ACCESSIBILITY ASSESSMENT

165715.24R000-005.303

ADA TITLE II ASSESSMENT

Alumni Building

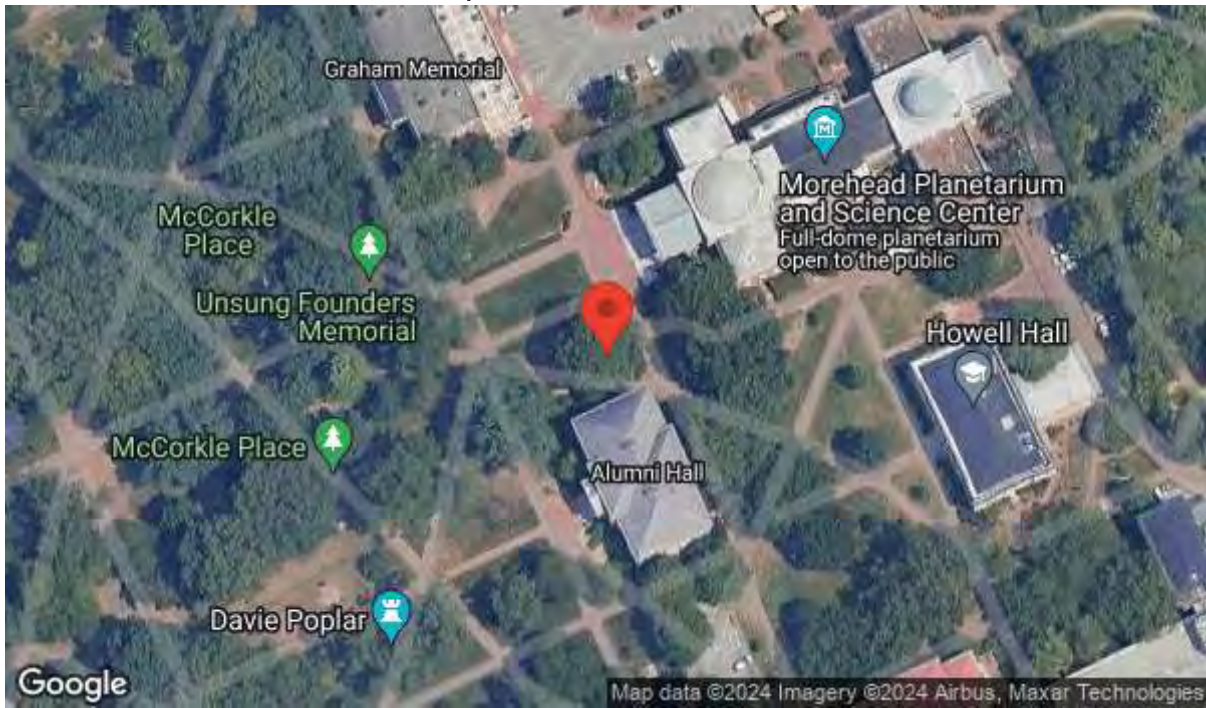
Assembly	Exterior Access Route
Type	Exterior Accessible Route
ADA Standard	403.3
Barrier Detail	The accessible route has cross slopes greater than 1:50 (2%).
Location Description	Accessible Entrance
Observed	May 21, 2024 by Brian.rogers@bureauveritas.com

The accessible route has cross slopes of 3.5% to 4.3% for a length of 30' x 15' wide.

The walkway should be graded to a maximum 1:50 (2%) cross slope. An accessible route has maximum 1:20 (5%) running slope and maximum 1:50 (2%) cross slope. [EXCEPTION: Cross slopes not exceeding 1:48 (2.08%) are permitted.] The clear width of walking surfaces shall be 36" minimum. [EXCEPTION: The clear width shall be permitted to be reduced to 32" minimum for a length of 24" maximum provided that reduced width segments are separated by segments that are 48" long minimum and 36" wide minimum.] Where grading to maximum running slope of 1:20 (5% running slope) is not possible, provide a compliant ramped surface within the walkway with maximum slope 1:12 (8.33%) and maximum ramp run rise of 6" without handrails. If a ramped surface with running slopes greater than 1:20 (5%) and maximum 1:12 (8.33%) rises more than 6", handrails are required. The cost estimate for this barrier removal is based on grading the running slope to maximum 1:20 (5%). The quantity and order of magnitude cost estimate provided for this barrier are limited to the extent of the area identified as non-compliant. Additional costs that may be associated with removal of the barrier are not included.

Photos for Barrier ID: AX456091

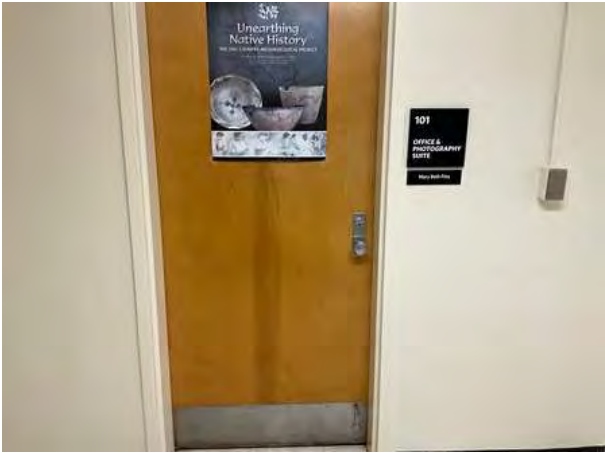
Assembly	Interior Access Route	
Type	Door	
ADA Standard	404.2.9	
Barrier Detail		
The opening force required to open the accessible, hinged, non-fire door is more than 5 pounds.		
Location Description	Room 101	
Observed	May 22, 2024 by Brian.rogers@bureauveritas.com	
Site Conditions	The door requires 13 pounds of pressure to open.	
Resolution		
Adjust the closer or replace with a door that requires no more than 5 pounds of force for pushing or pulling the door open. To be completed in conjunction with ID: 456091. The force at the latch, the force to set the door in motion, and the force to fully open the door shall be maximum 5 pounds. These forces do not apply to the force required to retract latch bolts or disengage other devices that hold the door or gate in a closed position.		
Quantity	Unit Cost	Total Cost
1 EA	0.00	\$ 0
Priority	1

Adjust closer or remove and replace closer to ensure that the door has a closure time of at least 5 seconds within 12 degrees of the latch. To be completed in conjunction with ID: 456092. Door closers and gate closers shall be adjusted so that from an open position of 90 degrees, the time required to move the door to a position of 12 degrees from the latch is 5 seconds minimum.

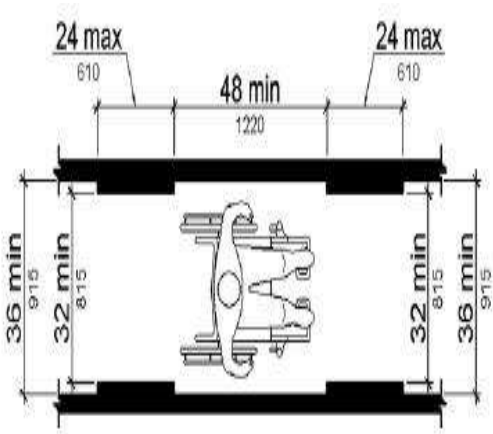
Assembly	Interior Access Route
Type	Interior Access Route
ADA Standard	305.3 and 402.5.1
Barrier Detail	Clear widths are less than 36" minimum, including protruding objects.
Location Description	Room 101A
Observed	May 21, 2024 by Brian.rogers@bureauveritas.com
Site Conditions	The clear width between the two utility tables is 25 inches.
Width	25"

Ensure clear widths of 36" minimum. [EXCEPTION: The clear width shall be permitted to be reduced to be 32" minimum for a length of 24" maximum provided that reduced width segments are separated by segments that are 48" long minimum and 36" wide minimum.]

Photos for Barrier ID: AX456089

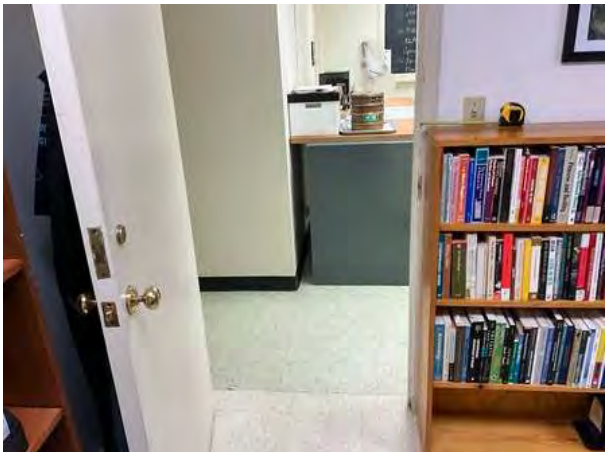
Assembly	Interior Access Route	
Type	Door	
ADA Standard	404.2.4; Table 404.2.4.1	
Barrier Detail		
The pull side of the accessible door does not have the required maneuvering clearances.		
Location Description	Room 103	
Observed	May 21, 2024 by Brian.rogers@bureauveritas.com	
Site Conditions		
For a front approach on the pull side of the door there's 2 1/2 inches to a wall that is 11 1/2 inches deep		
Dimensions	2 1/2"	
Resolution		
Redesign to provide the required maneuvering clearance at the pull side of the door. The required depth of the maneuvering clearance is 60" minimum. The required side clearance is 18" minimum on the latch side of the door. Maneuvering clearance shall extend the full width of the doorway and the required latch side clearance. Floor or ground space within the required maneuvering clearance shall be maximum 1:48 (2.08%) slope. Changes in level are not permitted.		
Quantity	Unit Cost	Total Cost

Photos for Barrier ID: AX456117

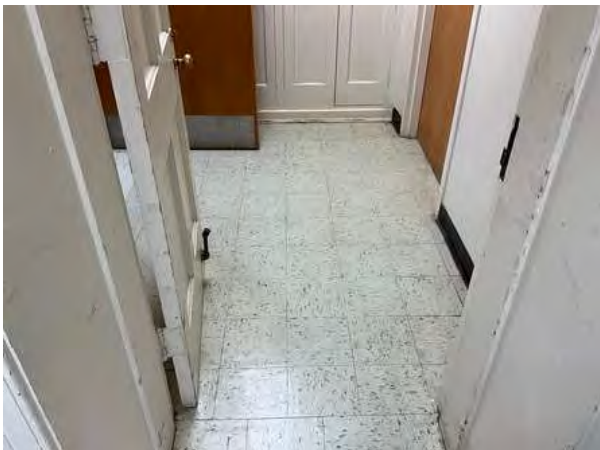
Assembly	Interior Access Route
Type	Door
ADA Standard	307.4, 404.2.3
Barrier Detail	The door has less than 32" clear width.
Location Description	Room 107
Observed	May 22, 2024 by Brian.rogers@bureauveritas.com
Site Conditions	The door has a 29 inch wide opening
Width	29"

Remove and replace with a door that has a minimum clear opening of 32". Door openings shall provide a clear width of 32" minimum. Clear openings of doorways with swinging doors shall be measured between the face of the door and the stop, with the door open 90 degrees. Openings more than 24" deep shall provide a clear opening of 36" minimum. There shall be no projections into the required clear opening width lower than 34" above the finish floor or ground. Projections into the clear opening width between 34" and 80" above the finish floor or ground shall not exceed 4". [EXCEPTIONS: 1. In alterations, a projection of 5/8" maximum into the required clear width shall be permitted for the latch side stop. 2. Door closers and door stops shall be permitted to be 78" minimum above the finish floor or ground.]

Photos for Barrier ID: AX456118

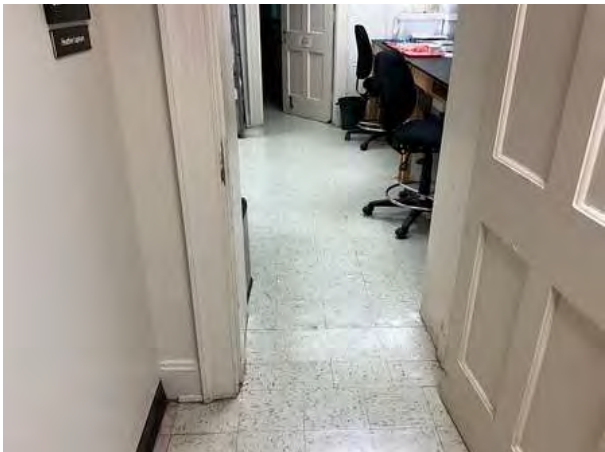
Assembly	Interior Access Route	
Type	Door	
ADA Standard	404.2.4; Table 404.2.4.1	
Barrier Detail		
The pull side of the accessible door does not have the required maneuvering clearances.		
Location Description	Room 107A	
Observed	May 22, 2024 by Brian.rogers@bureauveritas.com	
Site Conditions		
For a front approach on the pull side of the door A desk encroaches on the latch side of the door at 15 inches.		
Dimensions	15"	
Resolution		
Relocate the furniture to provide the required maneuvering clearance at the pull side of the door. The required depth of the maneuvering clearance is 60" minimum. The required side clearance is 18" minimum on the latch side of the door. Maneuvering clearance shall extend the full width of the doorway and the required latch side clearance. Floor or ground space within the required maneuvering clearance shall be maximum 1:48 (2.08%) slope. Changes in level are not permitted.

Redesign to provide the required maneuvering clearance at the pull side of the door. The required depth of the maneuvering clearance is 60" minimum. The required side clearance is 18" minimum on the latch side of the door. Maneuvering clearance shall extend the full width of the doorway and the required latch side clearance. Floor or ground space within the required maneuvering clearance shall be maximum 1:48 (2.08%) slope. Changes in level are not permitted.

Photos for Barrier ID: AX456122

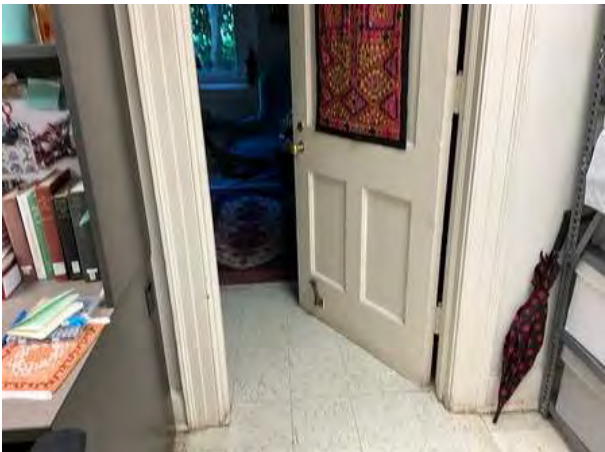
Assembly	Interior Access Route
Type	Door
ADA Standard	307.4, 404.2.3
Barrier Detail	The door has less than 32" clear width.
Location Description	Room 107B
Observed	May 22, 2024 by Brian.rogers@bureauveritas.com
Site Conditions	The door has a clear opening width of 29 inches wide
Width	29"

Remove and replace with a door that has a minimum clear opening of 32". Door openings shall provide a clear width of 32" minimum. Clear openings of doorways with swinging doors shall be measured between the face of the door and the stop, with the door open 90 degrees. Openings more than 24" deep shall provide a clear opening of 36" minimum. There shall be no projections into the required clear opening width lower than 34" above the finish floor or ground. Projections into the clear opening width between 34" and 80" above the finish floor or ground shall not exceed 4". [EXCEPTIONS: 1. In alterations, a projection of 5/8" maximum into the required clear width shall be permitted for the latch side stop. 2. Door closers and door stops shall be permitted to be 78" minimum above the finish floor or ground.]

Photos for Barrier ID: AX456109

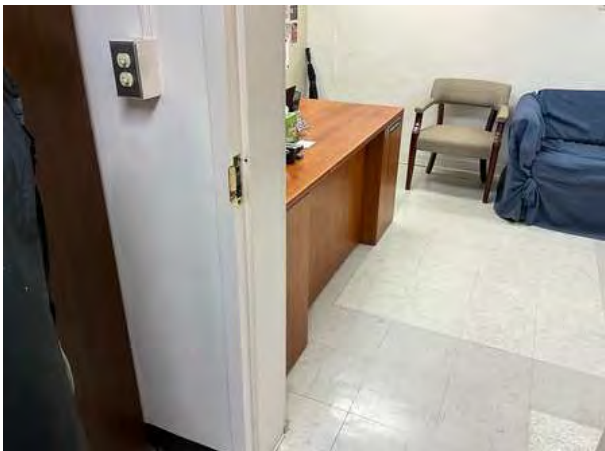
Assembly	Interior Access Route	
Type	Door	
ADA Standard	404.2.4; Table 404.2.4.1	
Barrier Detail		
The pull side of the accessible door does not have the required maneuvering clearances.		
Location Description	Room 109	
Observed	May 22, 2024 by Brian.rogers@bureauveritas.com	
Site Conditions		
For a forward approach on the pull side of the door there is 2 inches from the door jam to a 12 inch deep wall a bookcase and clear floor space at 37 inches from the face of the door.		
Dimensions	2"	
Resolution		
Redesign to provide the required maneuvering clearance at the pull side of the door. The required depth of the maneuvering clearance is 60" minimum. The required side clearance is 18" minimum on the latch side of the door. Maneuvering clearance shall extend the full width of the doorway and the required latch side clearance. Floor or ground space within the required maneuvering clearance shall be maximum 1:48 (2.08%) slope. Changes in level are not permitted.

Relocate the furniture to provide the required maneuvering clearance at the pull side of the door. The required depth of the maneuvering clearance is 60" minimum. The required side clearance is 18" minimum on the latch side of the door. Maneuvering clearance shall extend the full width of the doorway and the required latch side clearance. Floor or ground space within the required maneuvering clearance shall be maximum 1:48 (2.08%) slope. Changes in level are not permitted.

Photos for Barrier ID: AX456103

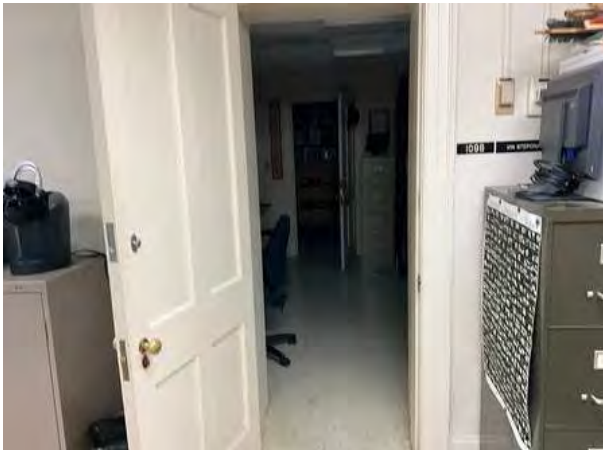
Assembly	Interior Access Route
Type	Door
ADA Standard	307.4, 404.2.3
Barrier Detail	The door has less than 32" clear width.
Location Description	Room 109B
Observed	May 22, 2024 by Brian.rogers@bureauveritas.com
Site Conditions	The door is 29 inches wide.
Width	29"

Remove and replace with a door that has a minimum clear opening of 32". Door openings shall provide a clear width of 32" minimum. Clear openings of doorways with swinging doors shall be measured between the face of the door and the stop, with the door open 90 degrees. Openings more than 24" deep shall provide a clear opening of 36" minimum. There shall be no projections into the required clear opening width lower than 34" above the finish floor or ground. Projections into the clear opening width between 34" and 80" above the finish floor or ground shall not exceed 4". [EXCEPTIONS: 1. In alterations, a projection of 5/8" maximum into the required clear width shall be permitted for the latch side stop. 2. Door closers and door stops shall be permitted to be 78" minimum above the finish floor or ground.]

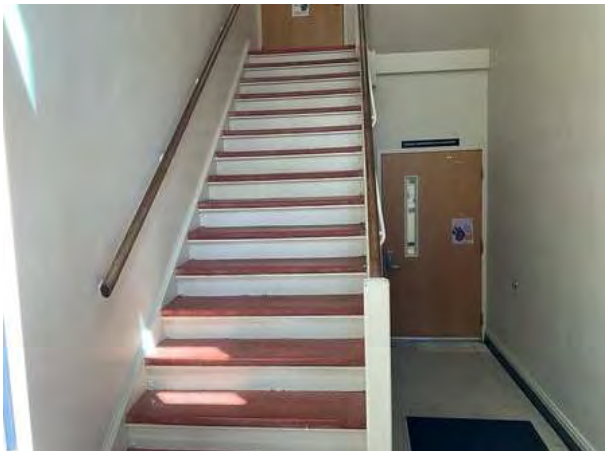
Assembly	Interior Access Route
Type	Stairs
ADA Standard	505
Barrier Detail	Handrails are not compliant.
Location Description	Stair ST-1 Parking side, ST-2
Observed	May 22, 2024 by Brian.rogers@bureauveritas.com

Install compliant handrails on both sides of the stairway. Inside handrails on switchback or dogleg stairs shall be continuous between runs. Top of gripping surfaces of handrails shall be 34" minimum and 38" maximum vertically above stair nosings. Handrails shall be at a consistent height above ramp surfaces. Clearance between handrail gripping surfaces and adjacent surfaces shall be 1-1/2" minimum. Handrail gripping surfaces shall be continuous along their length and shall not be obstructed along their tops or sides. The bottoms of handrail gripping surfaces shall not be obstructed for more than 20% of their length. Where provided, horizontal projections shall occur 1-1/2" minimum below the bottom of the handrail gripping surface. [EXCEPTION: The distance between horizontal projections and the bottom of the gripping surface shall be permitted to be reduced by 1/8" for each 1/2" of additional handrail perimeter dimension that exceeds 4".] Handrail gripping surfaces with a circular cross section shall have an outside diameter of 1-1/4" minimum and 2" maximum. Handrail gripping surfaces with a non-circular cross section shall have a perimeter dimension of 4" minimum and 6-1/4" maximum, and a cross-section dimension of 2-1/4" maximum. Handrail gripping surfaces and any surfaces adjacent to them shall be free of sharp or abrasive elements and shall have rounded edges. Handrails shall not rotate within their fittings. Handrail gripping surfaces shall extend beyond and in the same direction of stair flights. [EXCEPTIONS: 1. Extensions shall not be required for continuous handrails at the inside turn of switchback or dogleg ramps AND 3. In alterations, full extensions of handrails shall not be required where such extensions would be hazardous due to plan configuration.] At the top of a stair flight, handrails shall extend horizontally above the landing for 12" minimum beginning directly above the first riser nosing. At the bottom of a stair flight, handrails shall extend at the slope of the stair flight for a horizontal distance at least equal to one tread depth beyond the last riser nosing. Extensions shall return to a wall, guard, or the landing surface, or shall be continuous to the handrail of an adjacent stair flight. Removal of this barrier is required if the stairs are part of the required accessible means of egress from the accessible space, per emergency egress plans approved by the administrating local authority.

Photos for Barrier ID: AX456157

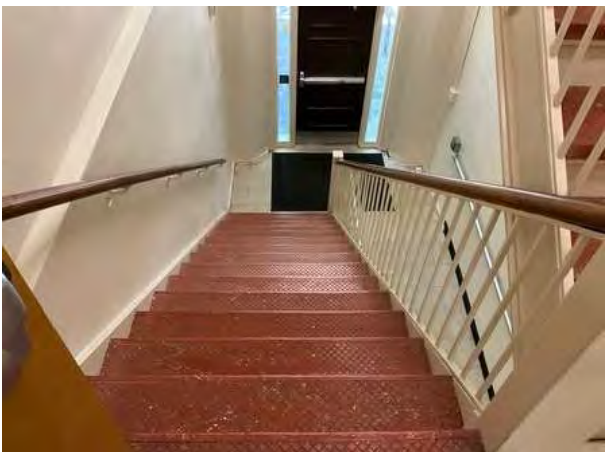
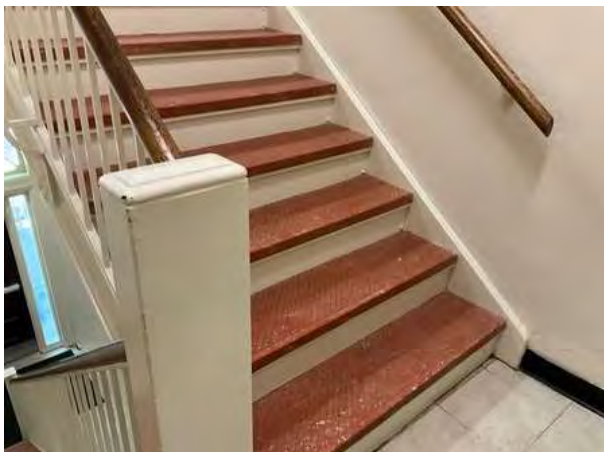
Assembly	Interior Access Route
Type	Reach Range
ADA Standard	308
Barrier Detail	Items that require a forward reach motion are not within reach range.
Location Description	All Light Switches
Observed	May 21, 2024 by Brian.rogers@bureauveritas.com

Install a visual contrast on each stair tread at the nosing. At stair nosings, the leading 2" of tread shall have visual contrast of dark-on-light or light-on-dark from the remainder of the tread.

Photos for Barrier ID: AX456094

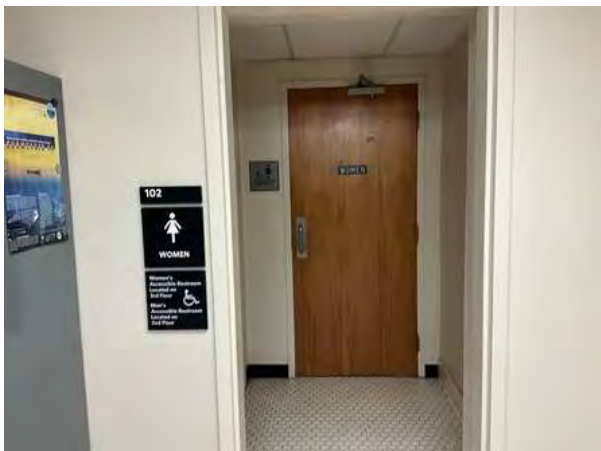
Assembly	Restroom
Type	Restroom/Bathroom - Door
ADA Standard	404.2.9
